Westinghouse

SUBJECT: Transmittal of Westinghouse Responses to Open Items Identified in the AP1000 Draft Safety Evaluation Report

AP1000 DESIGN CERTIFICATION REVIEW

Draft Safety Evaluation Report Open Item Response

Figure 19A.2-8-1: Floor Response Spectra of ASB Node at EL. 116.50'

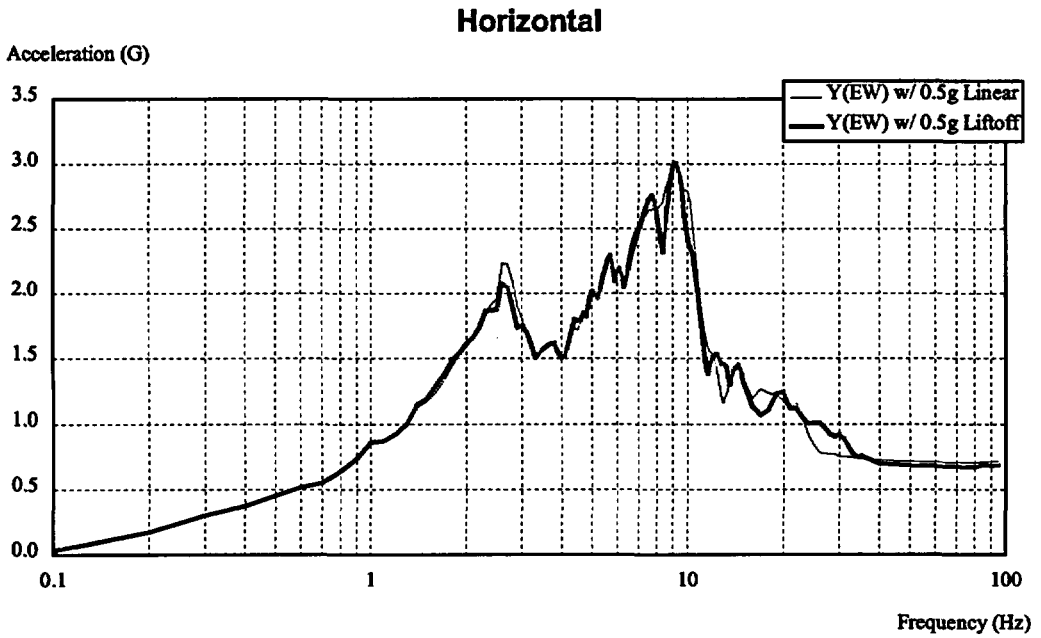
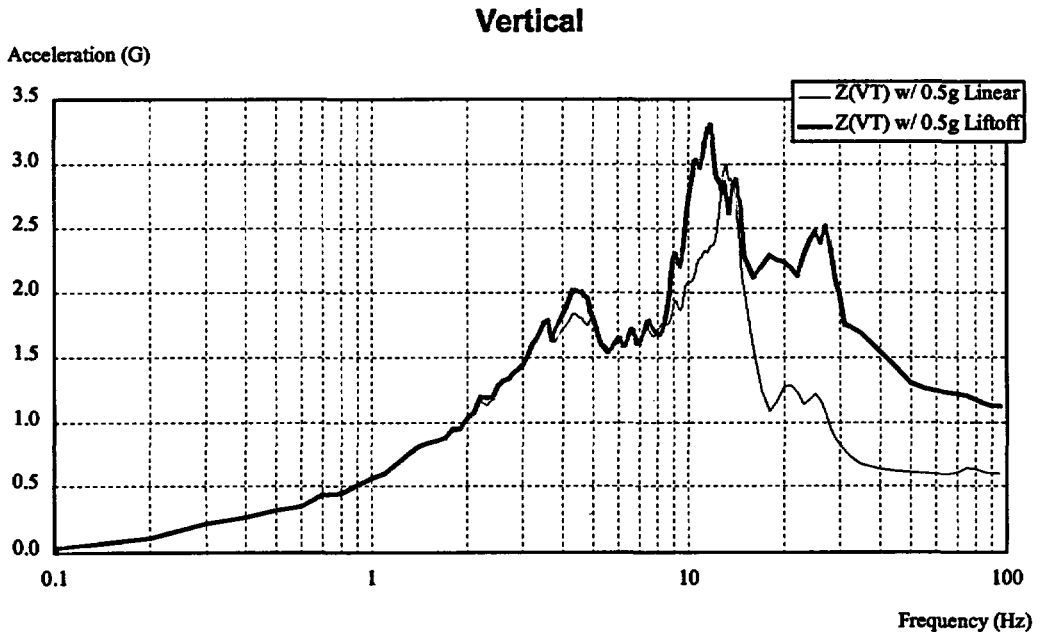
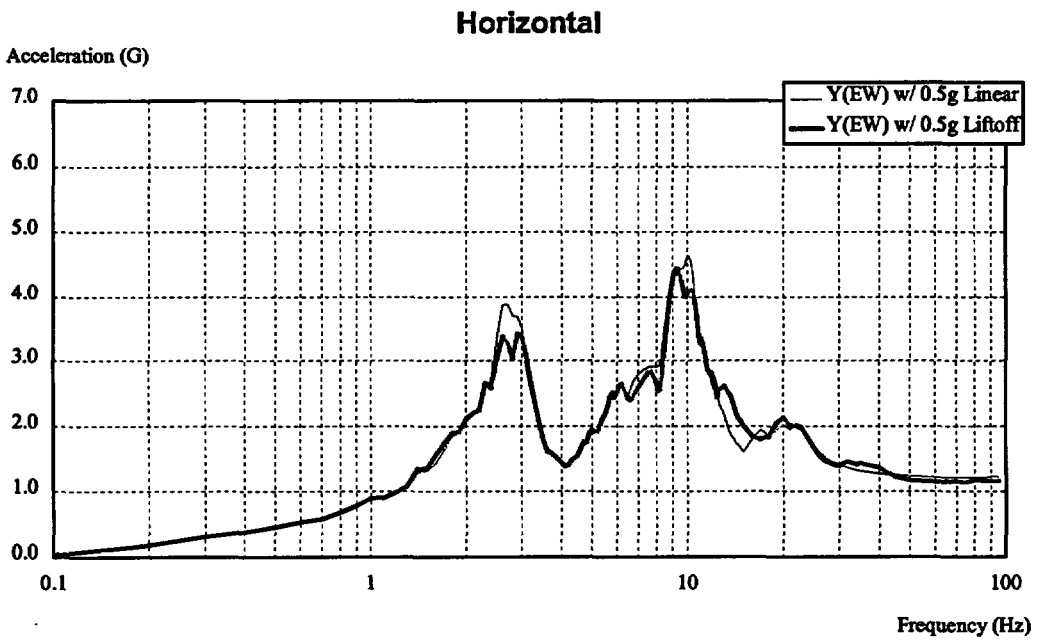
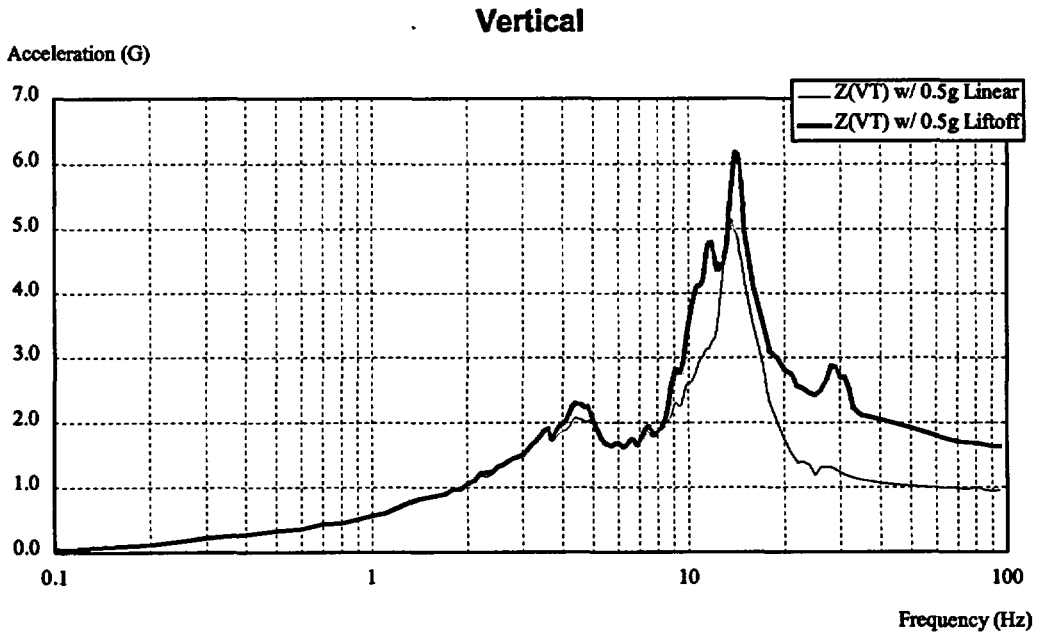
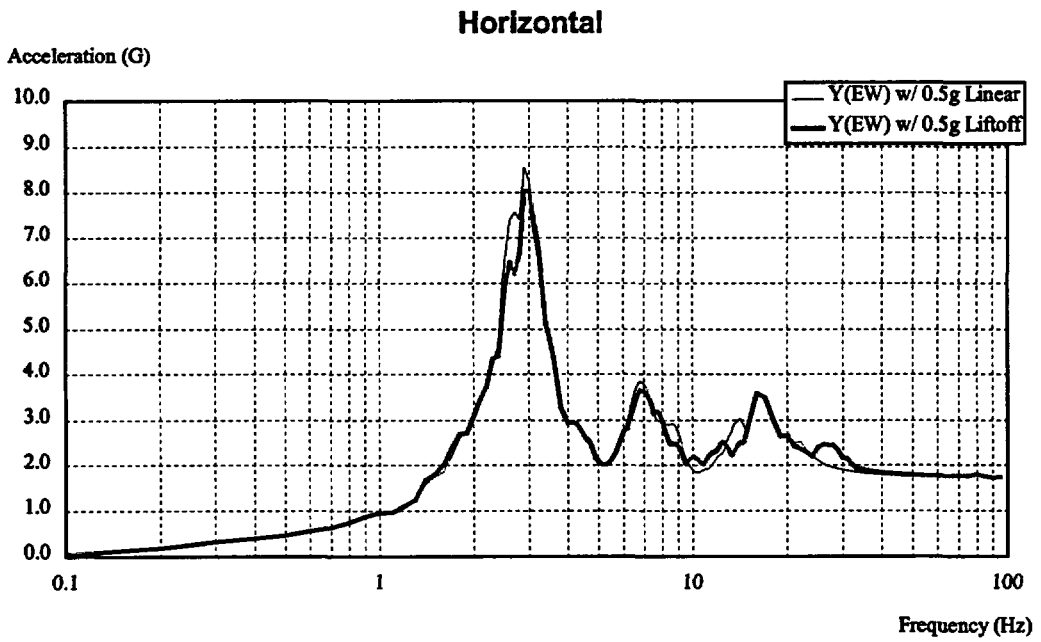
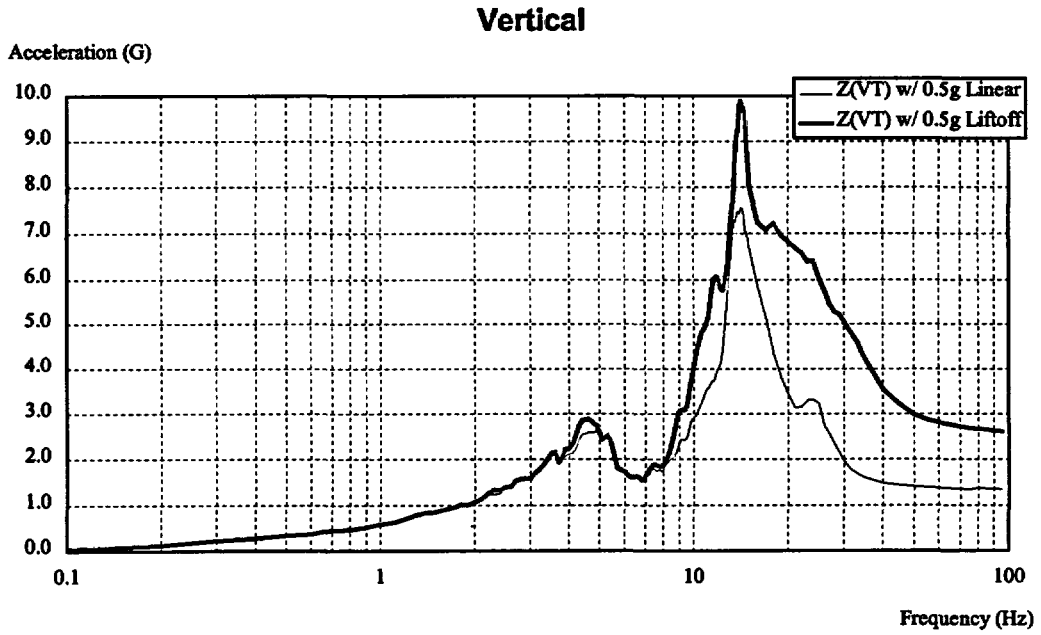
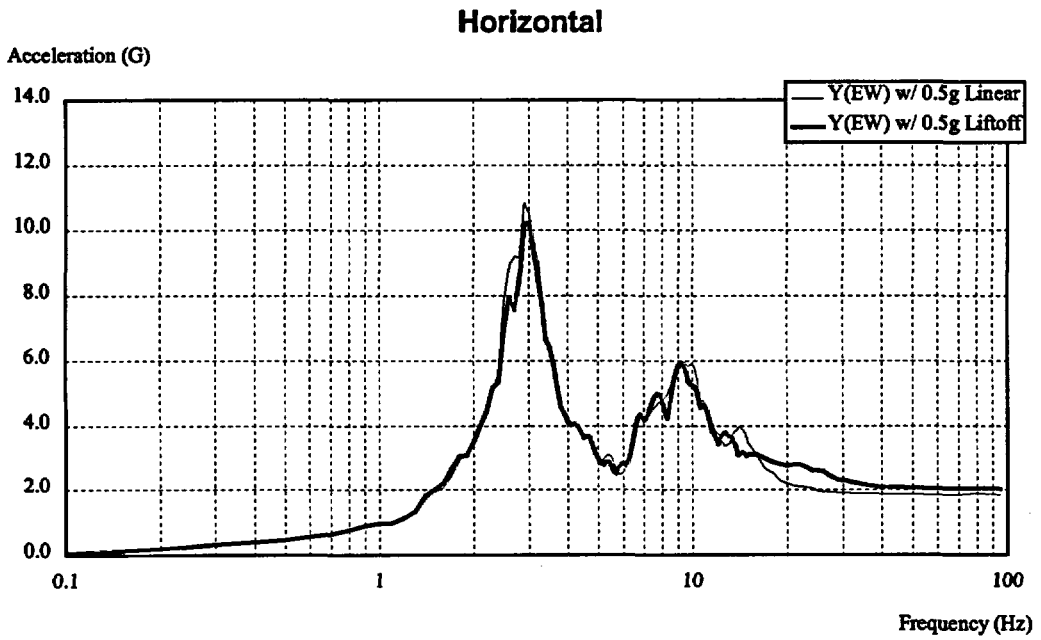
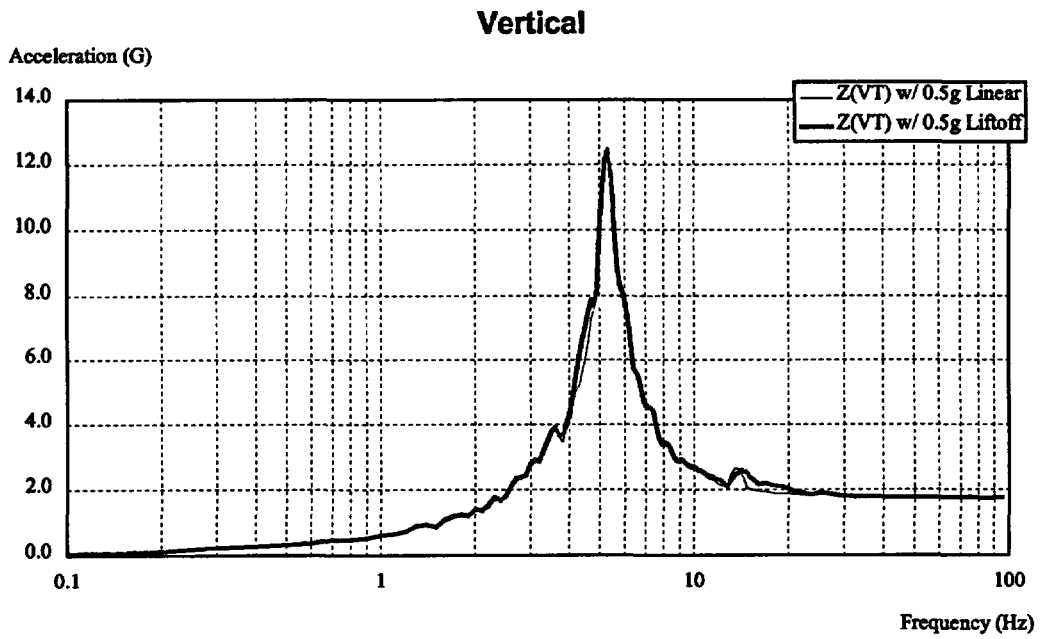
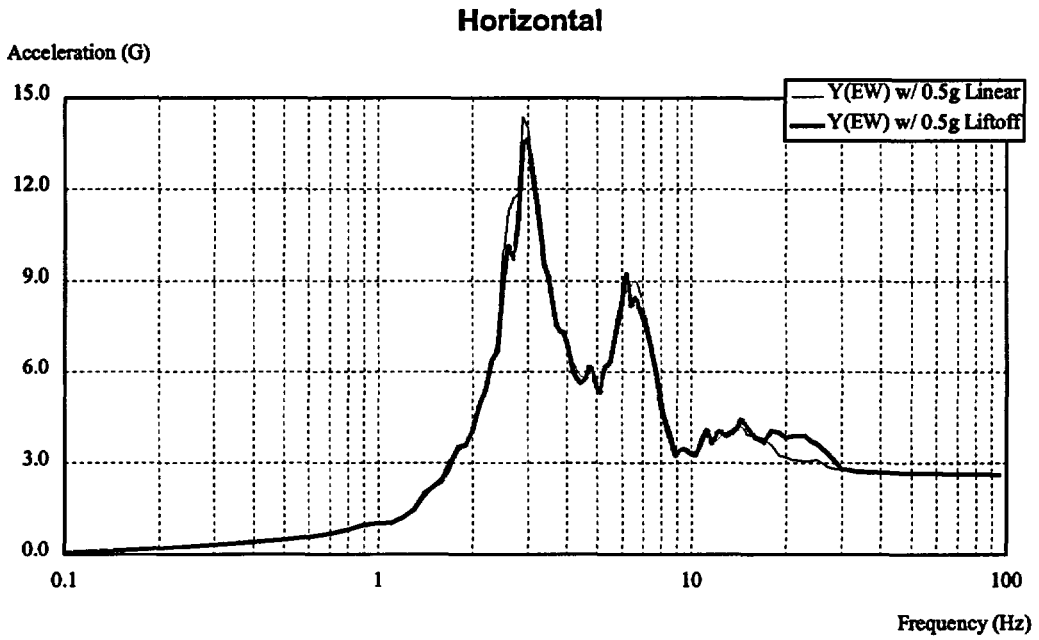
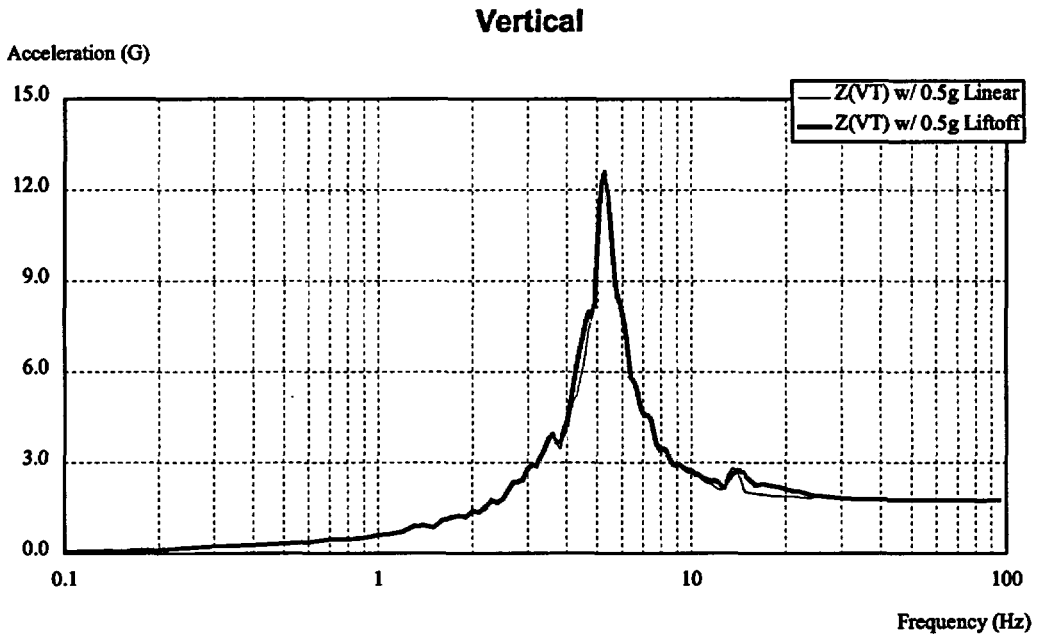
The applicant used the deterministic approach to estimate the HCLPF values of primary system component supports. The components included in the approach are: polar crane, baffle plate supports, heat exchanger for the passive residual heat removal system, core makeup tank and valves. The applicant used lower bound values, and it appears that there was no need for invoking factors of conservatism to arrive at the HCLPF values. It is noted that the core makeup tank has a HCLPF value of 0.54g; therefore, any increase in seismic response of the containment internal structure due to lift off of the internal structure or the nuclear island structure would necessitate a review of this HCLPF value. This is Open Item 19A.2-8.

This response is incomplete; it does not include the effect of CIS lift off.

In order to make conclusions for higher seismic events (> 0.3g), seismic response spectra (@5% equipment damping) were developed for the 0.5g case. Response spectra that include nonlinear liftoff effects were developed at different elevations using the auxiliary shield building (ASB) stick model described in DSER Open Item Number 3.7.2.3-1. The maximum uplift of the basemat is 0.29". In Figures 19A.2-8-1 to 19A.2-8-5 comparisons are made of these response spectra to the seismic response spectra using the linear ASB stick model. As seen from this comparison liftoff is not significant for horizontal response since the horizontal response spectra are similar. In the region of the shield building roof the vertical response spectra are comparable. There are differences in the vertical response spectra in the higher frequency region for the Shield Building cylinder up to elevation 265'. However, the differences shown in these curves will not affect the HCLPF values because:
